Update Instructions

SP005/04/P

Title: Extended High Voltage Power Supply for the FFDM-S a-SE Detector

The Full-Field Digital Mammography amorphous Selenium Digital Detector will be equipped with the Extended High Voltage Power Supply in order to improve its sensitivity. This in turn will allow for a decrease of dose.

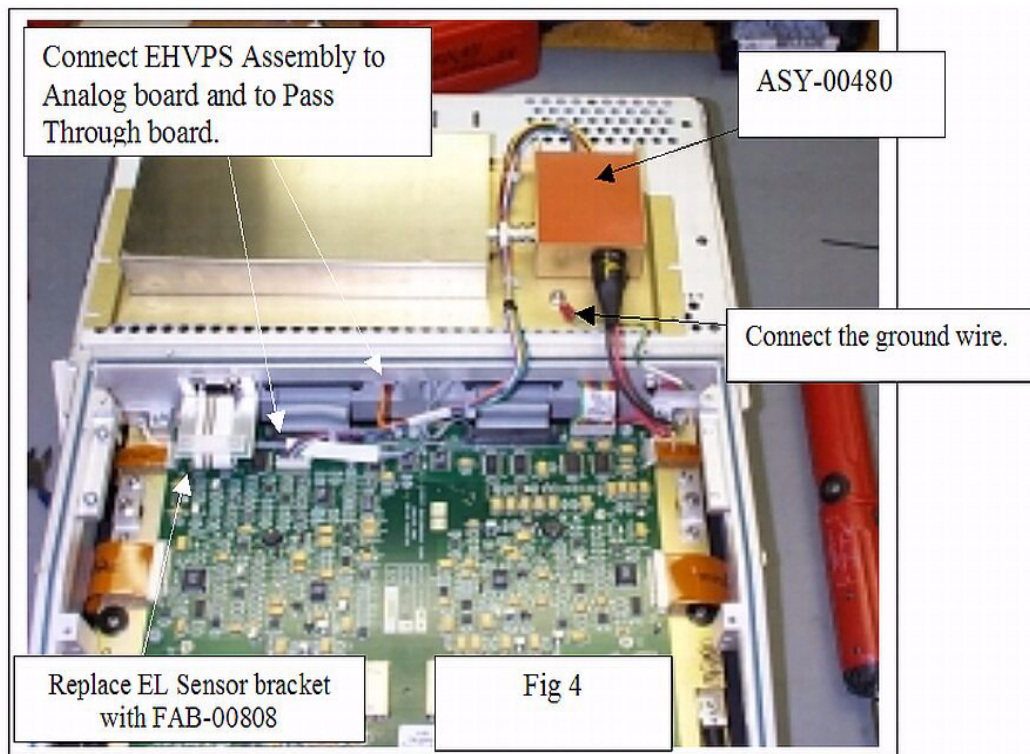
- 5.1.3 Remove the cable harness that connects the power supply to the analog board. See Fig 3.
- 5.1.4 Disconnect the High Voltage cable from the Gamma power supply.
- 5.1.5 Remove the Gamma power supply.

- 5.1.6 Change R127 to 64.9K ohm resistor (RES-00016)
- 5.1.7 Place a new Part Number label on the analog board indicating PCB-00029.
- 5.1.8 Add black ground wire (648122001) and 2 LKNT, Hex, #4-40, w/Nylon Insert (700436002) to ground the analog board to the base plate, see Fig 3.
- 5.1.9 Place EHVPs Unit Assembly (ASY-00480) upside down on top of the Electrical Box Assembly. See Fig. 4.
- 5.1.10 Connect the cable harness to the Pass Through board and to the Analog board. See Fig. 4.

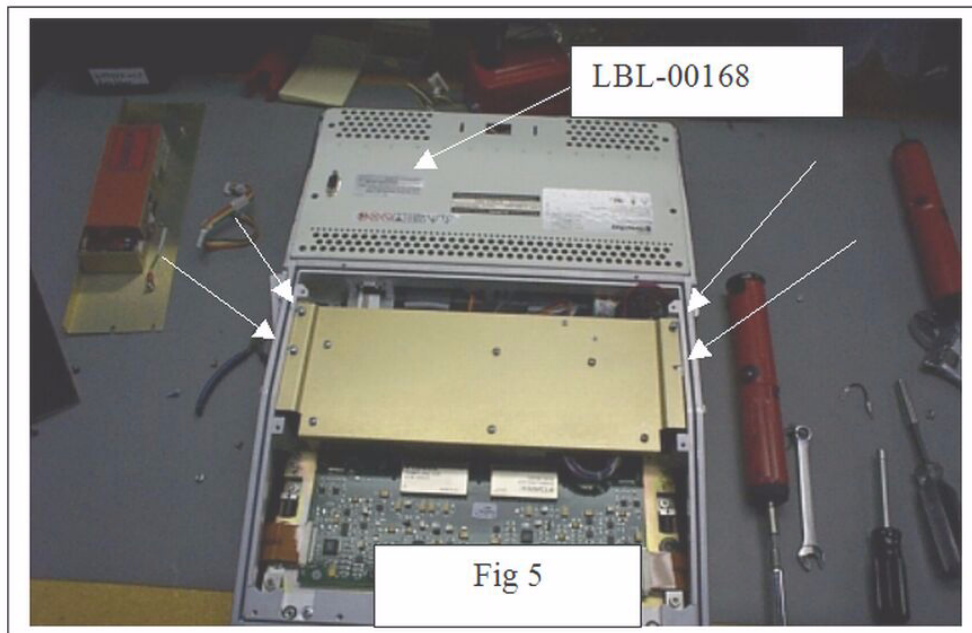
- 5.1.11 Connect the High Voltage cable to the EHVPS unit. See Fig 4.
- 5.1.12 Connect the ground wire to the EHVPS unit ground stud. See Fig 4.
- 5.1.13 Remove EL Sensor bracket and replace with FAB-00808.
